SERVICE INFORMATION BULLETIN

APPLICABILITY: 2015-2018MY Legacy

NUMBER: 12-268-19

SUBJECT: Mounting Bolt Change: Mass Damper Plate and Sub-Woofer

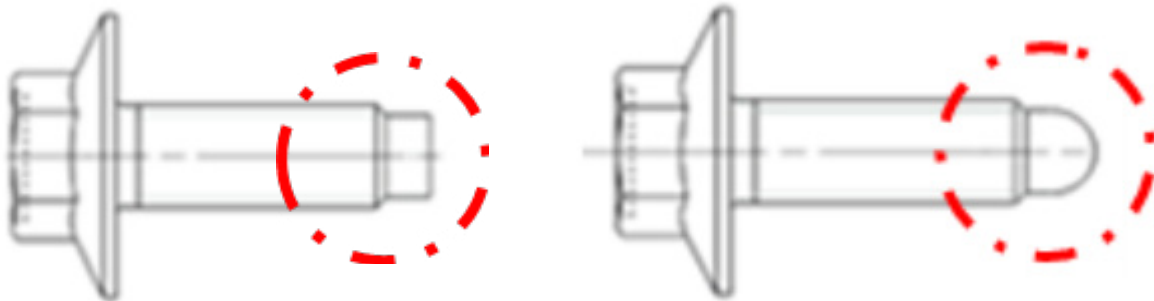
This Service Information bulletin announces a change made to the mass damper plate and sub-woofer mounting bolts. The threaded end of the new bolts has been changed to a round type instead of square to prevent getting caught on items as they are loaded into and out of the trunk.

- **901270013** for the sub-woofer (hex bolt & washer assembly)
- **901000474** for the mass damper plate (flange-type bolt as shown).
